ICC A117.1 Committee Action Report

Proposal list to the 2017 A117.1 for the 2023 edition – 2-24-2022 through 7-28-2022

FIGURE 304.3.2.1.1
T-SHAPED TURNING SPACE
NEW BUILDINGS - OVERLAP

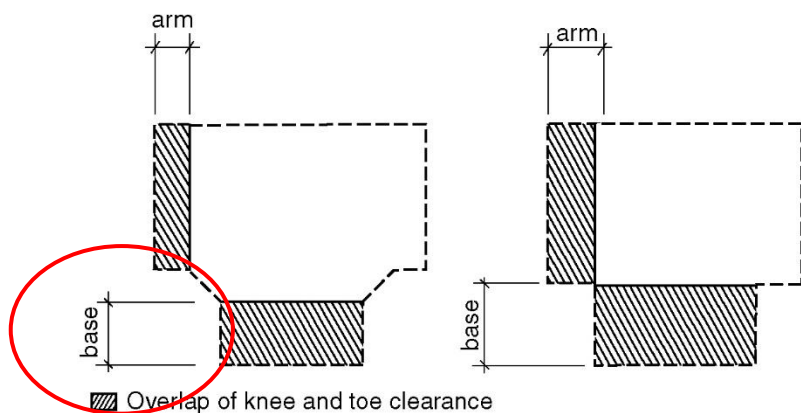
304.3.2.1.1 Overlap. Turning spaces shall be permitted to include knee and toe clearance complying with Section 306 of either the base or one arm. For Option 1, the base or arm is the portion beyond includes the chamfer.

REASON: The purpose of this proposal is to coordinate the overlap allowances for turning spaces. The A117.1 decided not to change the knee and toe clearances between the 2009 and 2017 edition. The turning spaces have increased in size and substantially limited the overlap at the same time. Since the circle and T-turn are to turn 180 degrees, they should be consistent – while now there are substantial differences in all 4 options. With the larger turning space, these proposals will still be a reduction on the total percentage of the turning space permitted under the

FIGURE 405.9.2.2

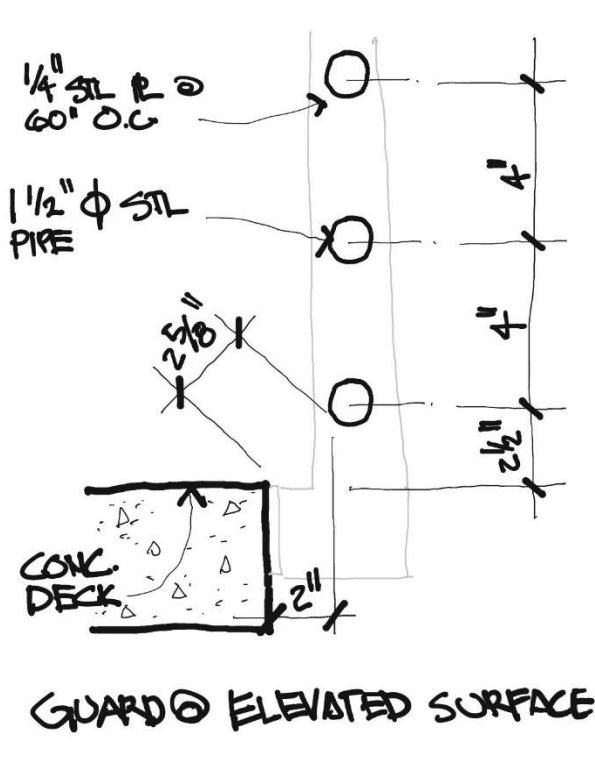
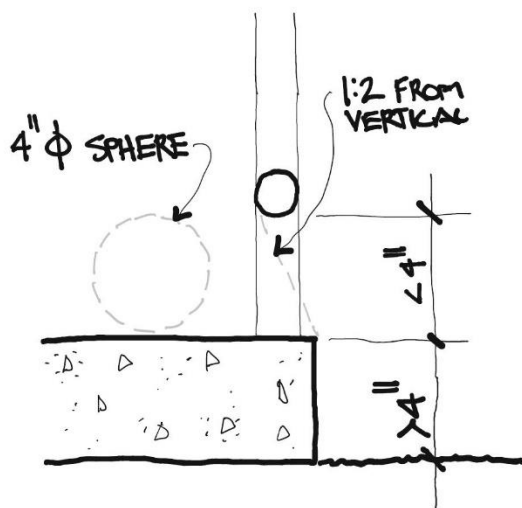
Staff note: Direction is required for changes to Figure 405.9.2.2.

Reason: To clarify some issues that may arise with where the edge protection would be required that would be problematic.

Report for 04-02- 2021		
Committee decision: D	Committee Vote at Meeting: 28-0-3	Committee Vote on Ballot:
REPORT OF HEARING:		
Modification (if any):		
Committee Reason: Adding edge protection at the locations indicated raised concerns about the potential for tripping hazard for non-wheelchair users. Issues with guards should be addressed in the building code since they are not required in ICC A117.1. code. The proposed language is not clear for if this requires a curb or railing; and the extent of where this would be required is not clear.		
PUBLIC COMMENT- FIRST DRAFT:		
Proponent:		
Desired Action:		
Modification:		
Reason:		
Committee decision: AS/AM/D	Committee Vote at Meeting:	Committee Vote on Ballot:
REPORT OF HEARING – FIRST DRAFT		
Modification (if any):		
Committee Reason:		
PUBLIC COMMENT- SECOND DRAFT:		
Proponent:

Figure 404.2.5(A) Two Doors or Gates in a Series - New Buildings

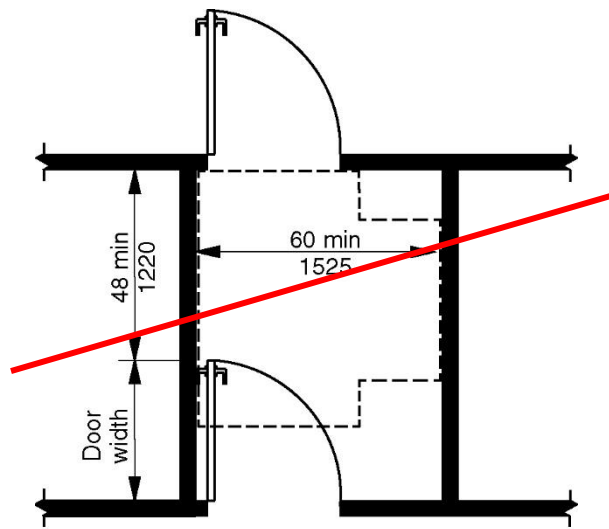
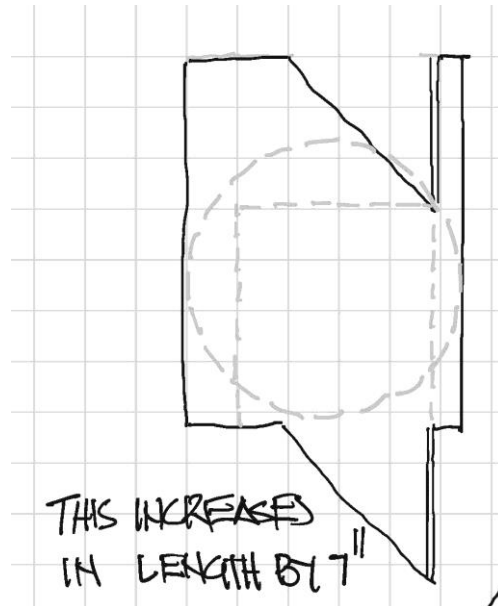
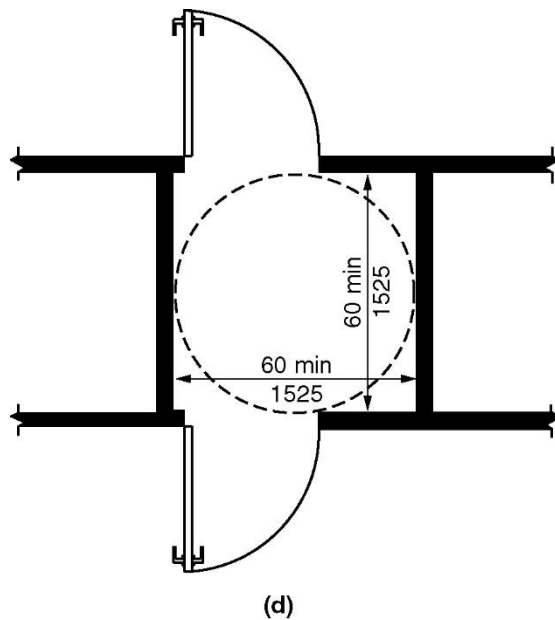
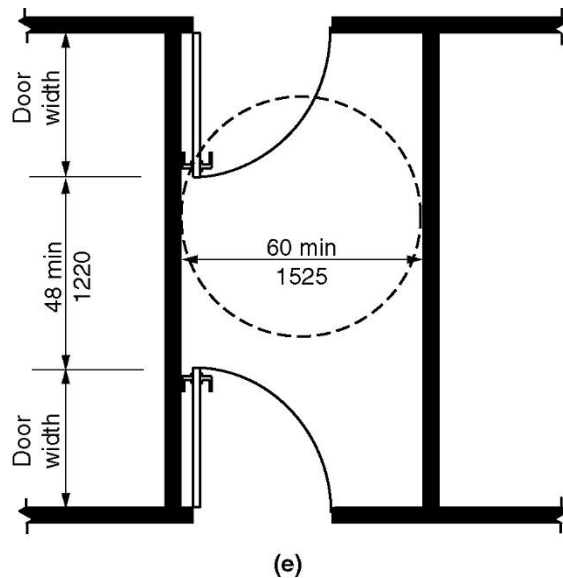
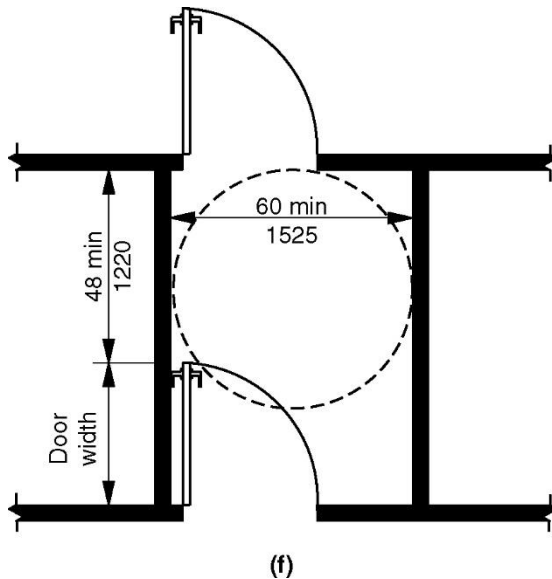
Note: The vestibule would increase by 4" due to the increase in the maneuvering clearance for forward approach. Drawing will all be revised include door maneuvering spaces.

Staff note: If this proposal is accepted, the committee will need to provide direction on changes to Figures 404.2.5(A) through 404.2.5(F).

**FIGURE 406.2(A)
PERPENDICULAR CURB RAMP**

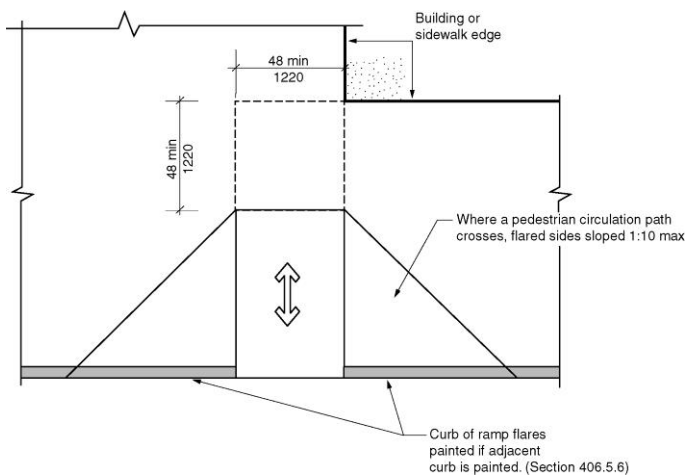
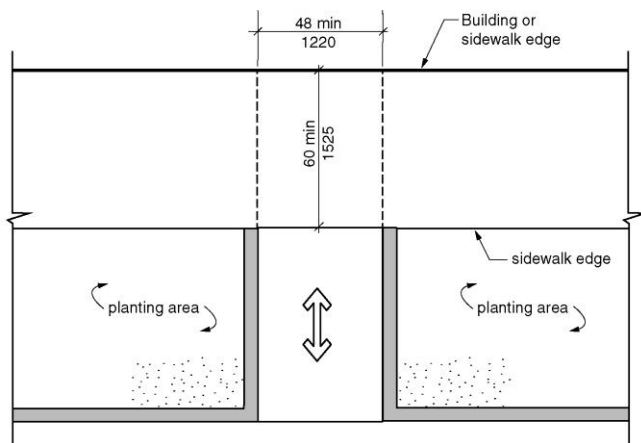
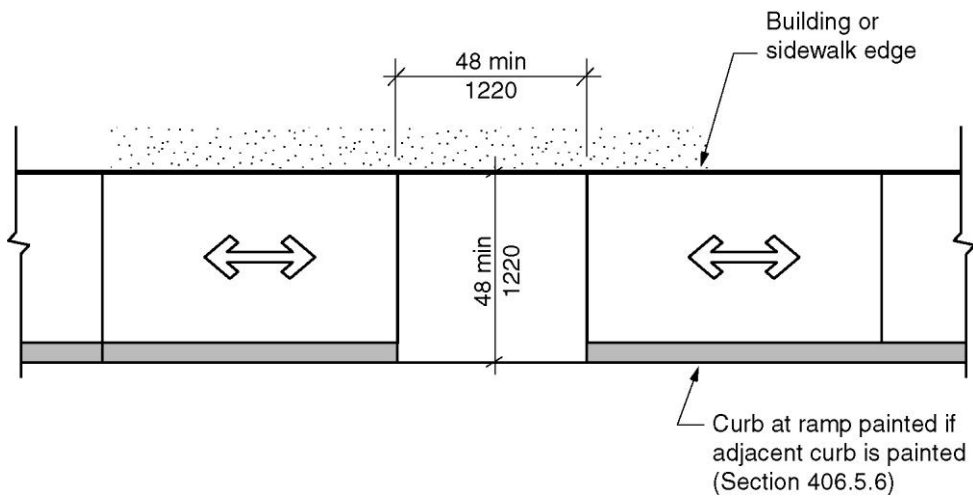
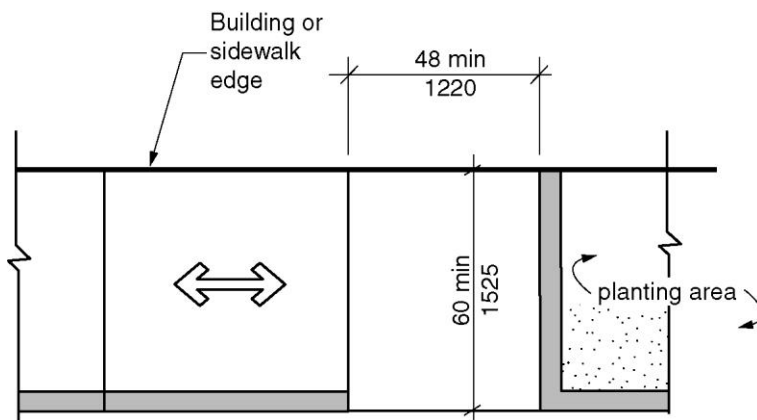
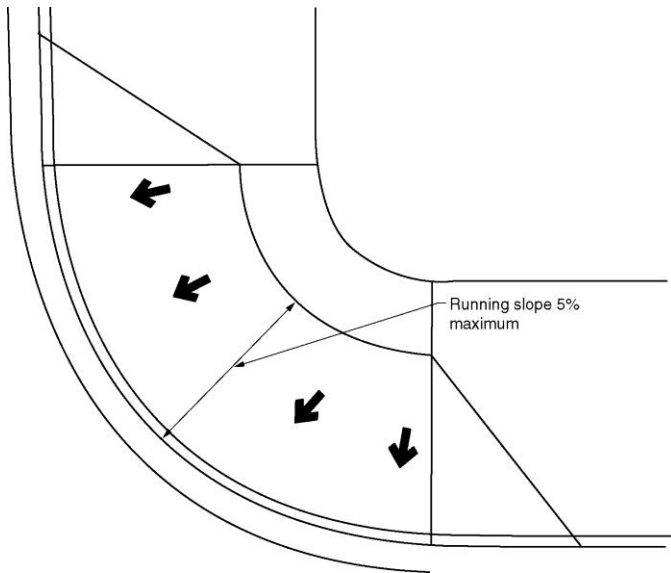
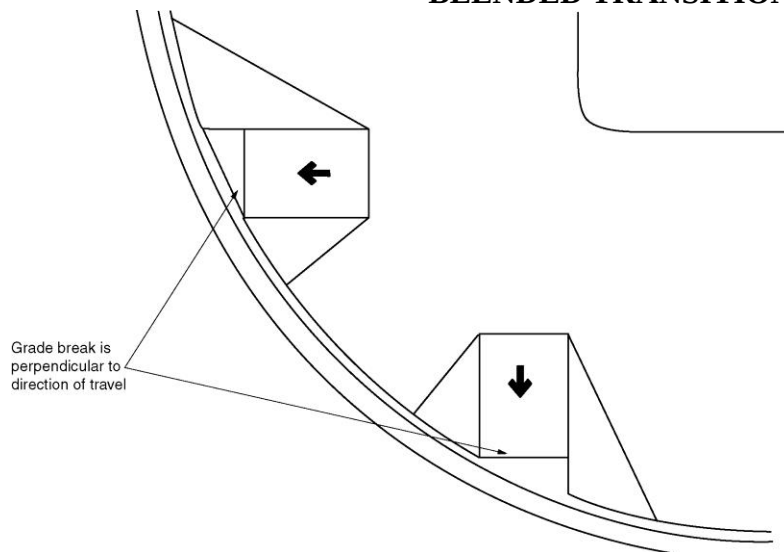
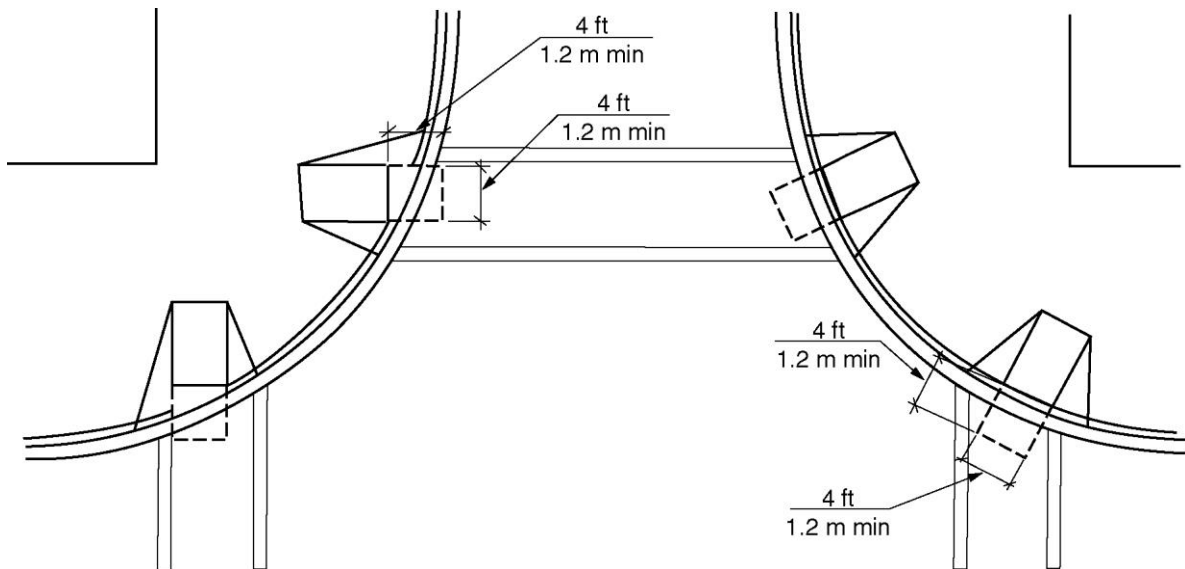
Note: These figures should all show detectable warnings.

REASON: Curb ramps are not complete without detectable warnings. While there is a section showing detectable warnings on curb ramps in some detail, they should not be omitted here. It implies that they are not required. Wherever curb ramps are depicted, unless they are not required to have detectable warnings, as in Figure 502.9.1, the detectable warning should be included. Figure 502.9.1.2 correctly includes the detectable warning, even though it is in Section 502 Parking Spaces.

Committee Reason: The first modification was approved because the committee felt that it was important to clarify that detectable warnings were only required in limited situations, thus the addition of the note in each drawing. The 2nd modification was approved to remove the original proposal’s suggestion to show the detectable warning on each curb cut. The committee felt that many people just looked at the pictures rather than the text, so showing the detectable warnings

**FIGURE 502.9.1
WIDE SIDEWALKS**

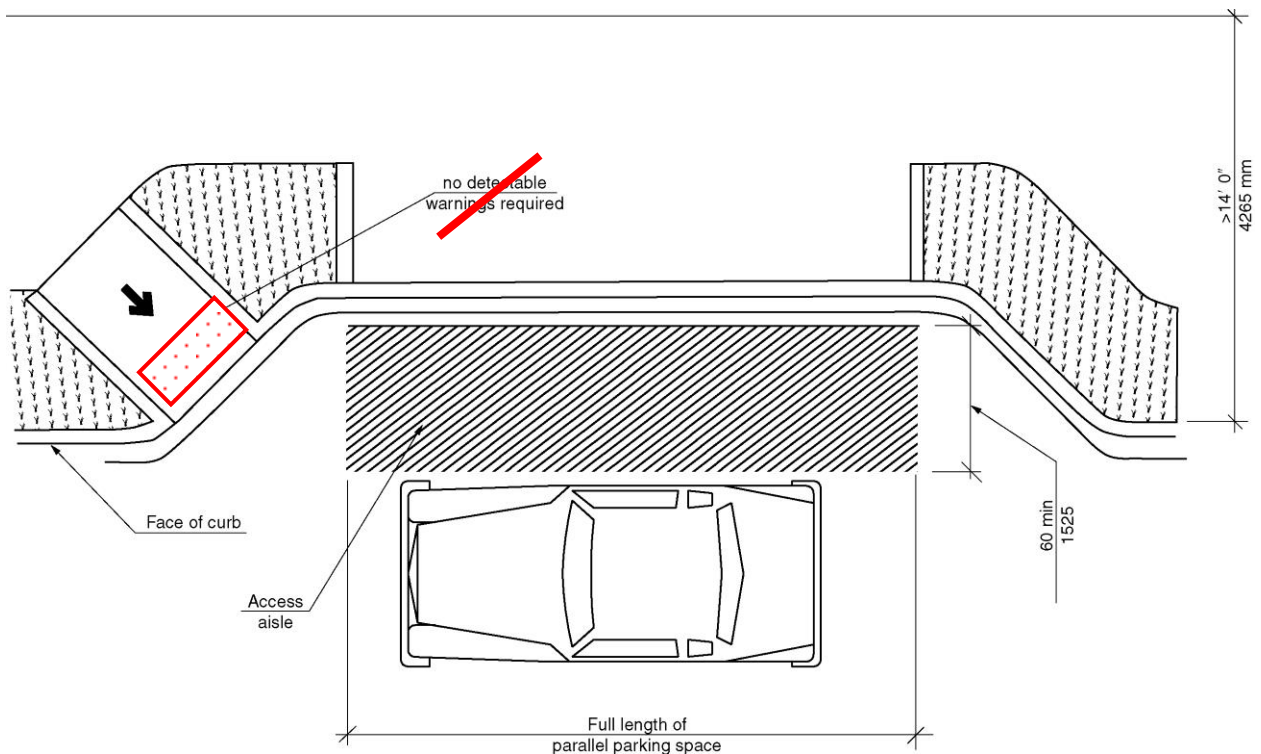
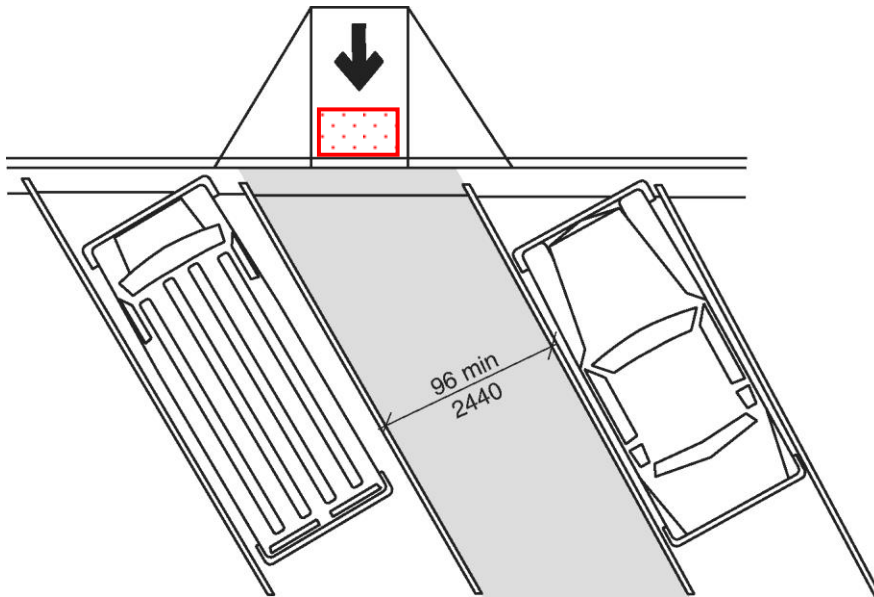
Note: The curb ramp in this figure should show detectable warnings.

REASON: Curb ramps are not complete without detectable warnings. While there is a section showing detectable warnings on curb ramps in some detail, they should not be omitted here. It implies that they are not required. Wherever curb ramps are depicted, unless they are not required to have detectable warnings, as in Figure 502.9.1, the detectable warning should be included. Figure 502.9.1.2 correctly includes the detectable warning, even though it is in Section 502 Parking Spaces.

**FIGURE 503.3(A)
PASSENGER LOADING ZONE ACCESS AISLE - NEW BUILDINGS**

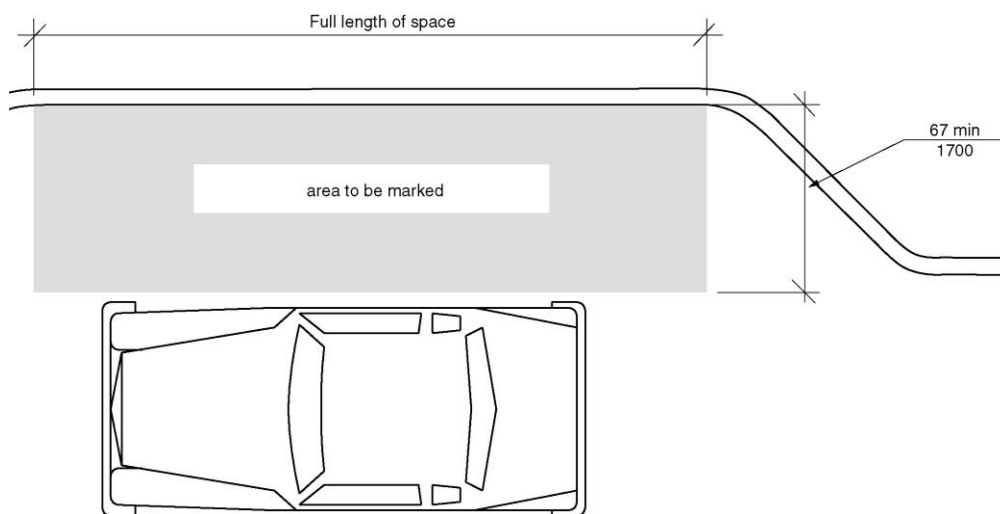
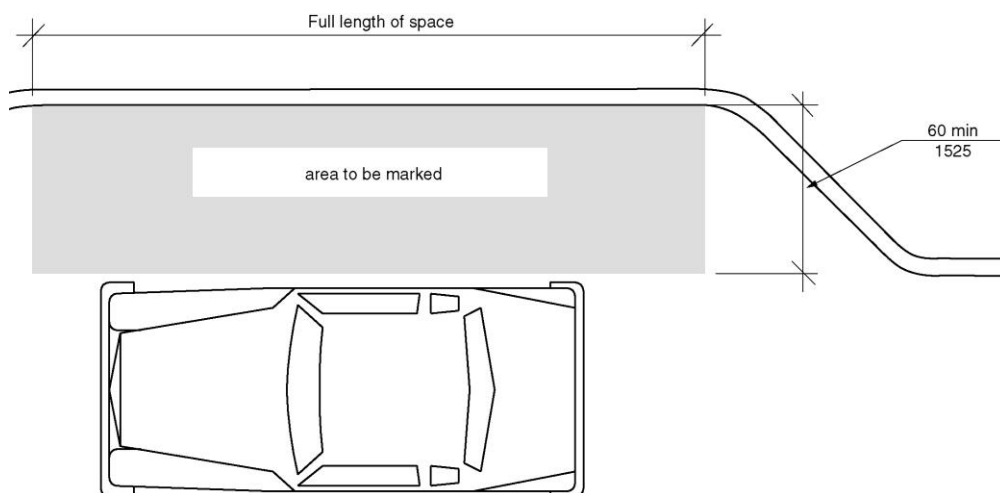
Note: Add curb ramps
